Delegated Report

Householder and Listed Building Consent Applications

Planning Application No: 20240178
20240179

Location: Old Vicarage Church Street Higham Rochester

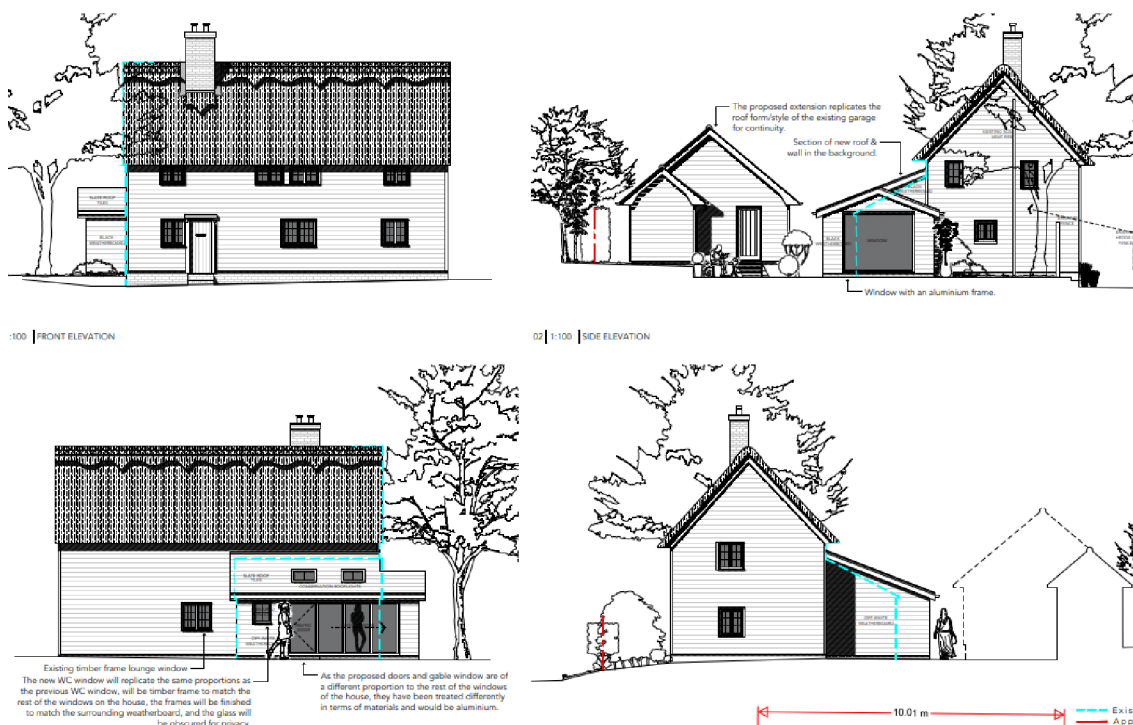
The proposed single storey rear extension would be built on the site of the existing single storey rear element which is to be demolished so the actual additional footprint would be 9.75 sq. m. The extension would extend out from the west flank elevation by 1.28m and would be 1.1m greater in depth than the existing single storey rear element.

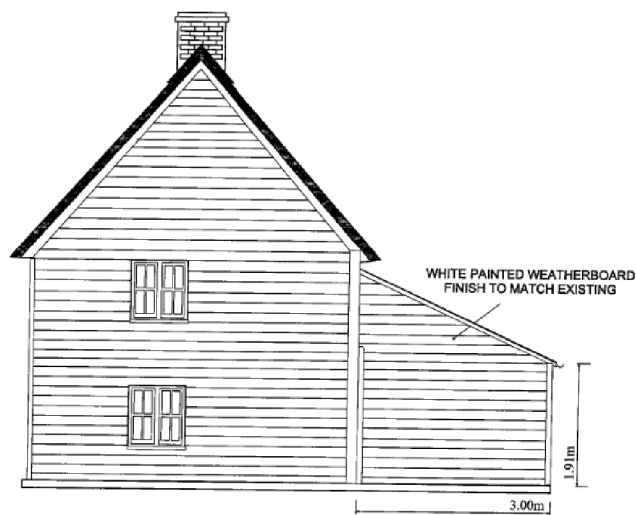
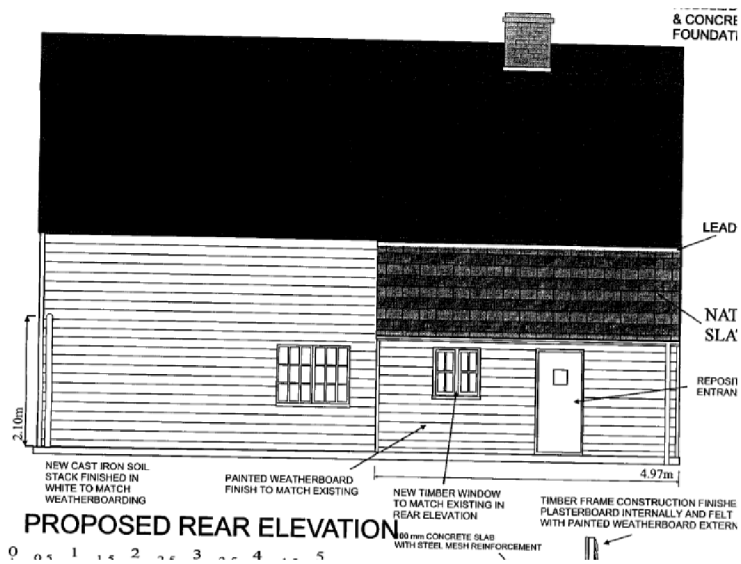
The proposed extension would result in an increase in built form at the side of the dwelling and increase its depth.

The proposal would therefore add additional floorspace, footprint, volume and increase the width and depth of the dwelling. The increase in floorspace would be modest and well under the one third limit set in saved Policy CS13 (LPFR). The increase in footprint would be modest as it would be mostly built on the footprint of the existing single storey rear element. The volume is considered modest and the extension would be subserviently designed in comparison to the host dwelling. Overall therefore based on all factors the proposed single storey rear extension is not considered a disproportionate addition.

SIDE ELEVATION (WEST)

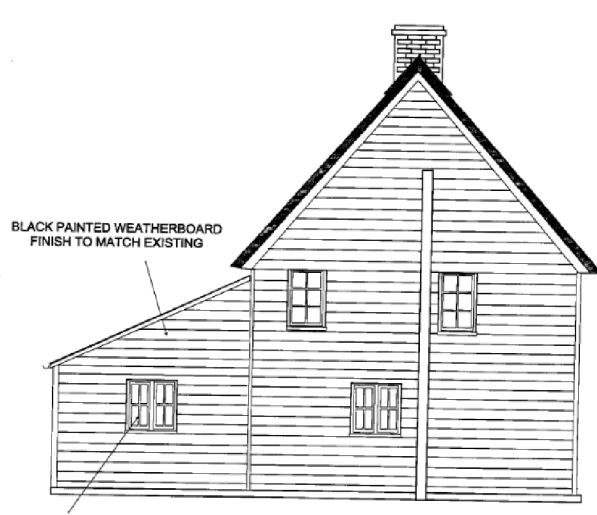
The 2008 planning and listed building consents (refs. 20080356 and 20080357) permitted a single storey rear extension which was 3m in depth and therefore 800mm greater than the existing single storey rear extension. The 2008 permissions would therefore have reduced the gap between the house and the detached garage. This current proposal would reduce it slightly further as it would be 3.3m in depth.

Although it would only be an additional 300mm which is a minimal amount it would not be appropriate to reduce the gap any further than what has been permitted.

The 2008 approval was built in line with the flank wall on its west side and did not project beyond it whereas the current proposal would do so by 1.2m. Whilst this projection may be acceptable on an unlisted property which is not in a Conservation Area, on this 16th century listed cottage consideration needs to be given to the siting and design of an extension. The significance of this listed building is particularly based on its simple vernacular form and character. There is a later extension to the property (from a review of the historic map regression on the Kent Historic Environment Record the earliest map of 1871-1890 shows an extension in that place) but it is modest and the scale and character of the listed building has been retained; as advised by the Conservation Officer it is in keeping with the vernacular of this listed building. The proposal to off-set the extension such that it would project 1.2m beyond the western flank wall would appear incongruous to the plan form of this listed building and also undermine and diminish the character of the listed building as a rear extension would be visible from the front of the dwelling. It is appreciated that the existing gate, boundary fence, landscaping and level difference between the house and the road would mean that the extension would have reduced visibility from the road however, it would be visible as the top part would be seen above the gate and fencing and in any case as this is a listed building for which great weight should be given to its conservation (paragraph 205 of the NPPF 2023) if something is not publicly visible it does not mean it is not still harmful to the listed building. The projection beyond the west flank wall would therefore be unacceptable as it would be harmful to the significance of this listed building and also the Conservation Area.

SIDE ELEVATION (EAST)

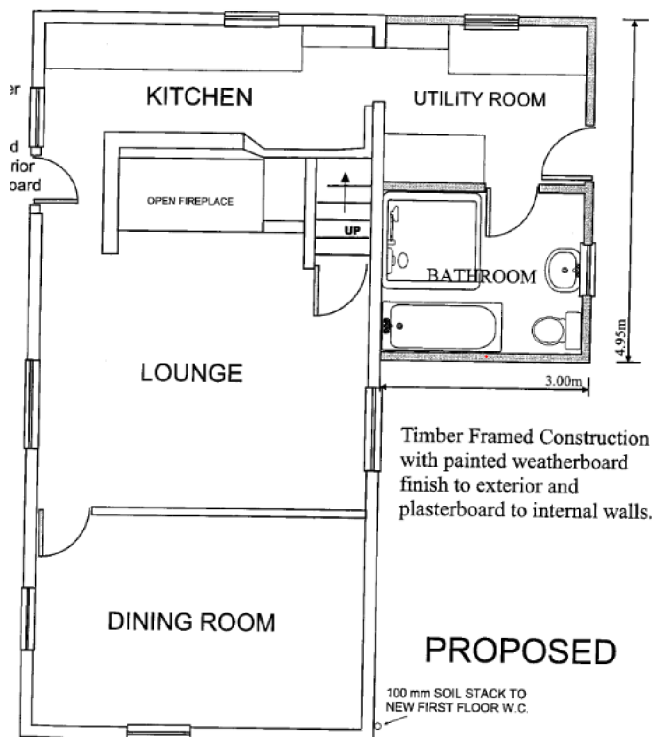
In respect of fenestration the approved extension had sympathetic fenestration with a simple timber window and door in the rear elevation and timber window in the flank elevation which was in keeping with the character of the building. However, in this current proposal the fenestration would not reflect the fenestration in the host dwelling in respect of its size, style and materials. The listed building has similarly sized and shaped square and rectangle windows which align with each other and are a sympathetic timber material. The proposed aluminium bi-fold doors in the rear elevation and large aluminium window in the west flank elevation would by virtue of their size, design and materials be completely out of keeping with the fenestration in the existing dwelling and harmful to the character of the conservation area as would the rooflights.
